ADDRESSEES	: Owners and operators ABC FleetAssist
VEHICLE MODEL	: CX35/CX45
MANUAL CHAPTER	: 10.70 Lavatory compartment – Door locking system
BULLETIN TYPE	: Service information
DATE	: September 30th, 2026
SUBJECT	: New lavatory door lock microswitch
CONDITIONS	: This service bulletin does not entitle to any reimbursement.

Figure 3

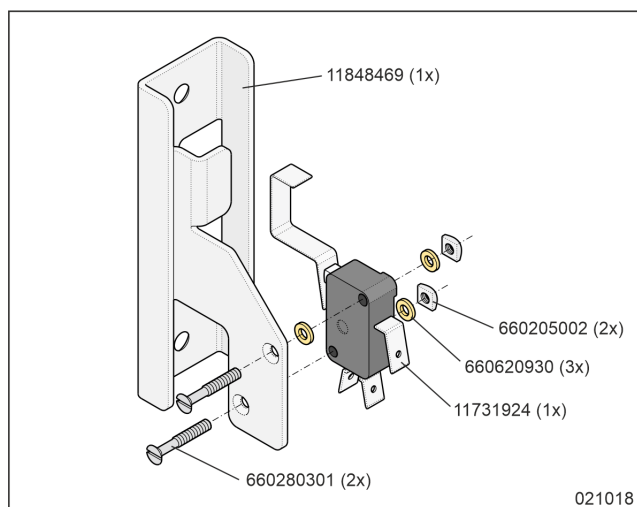
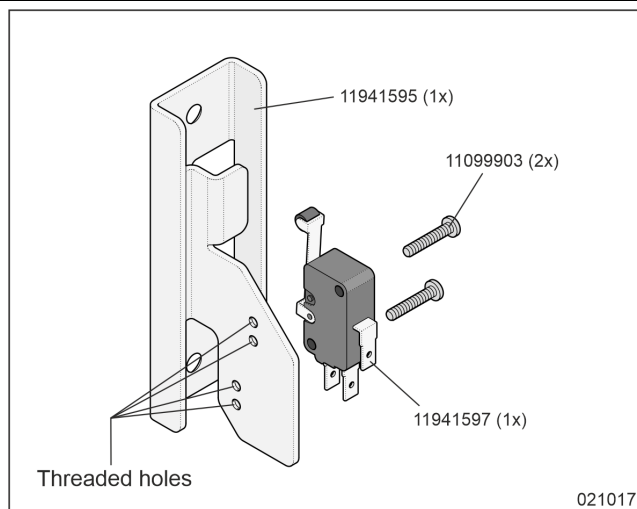
*VH11298189 is the reference number for the microswitch as it is delivered by the manufacturer. Because the straight lever of the microswitch must be folded for our application (refer to figure 3), it gets reference VH11731924.

- The new microswitch must be installed with the new bracket and specified fasteners.
- Refer to the material lists for a comparison between the old and the new parts.
- The old microswitch may be ordered as service replacement until stock has depleted.
- Parts may be ordered through regular channels.

VH reference	Description	Quantity*
11941597	Microswitch	1
11941595	Microswitch bracket	1
11099903	Screw M3 (length 16 mm)	2
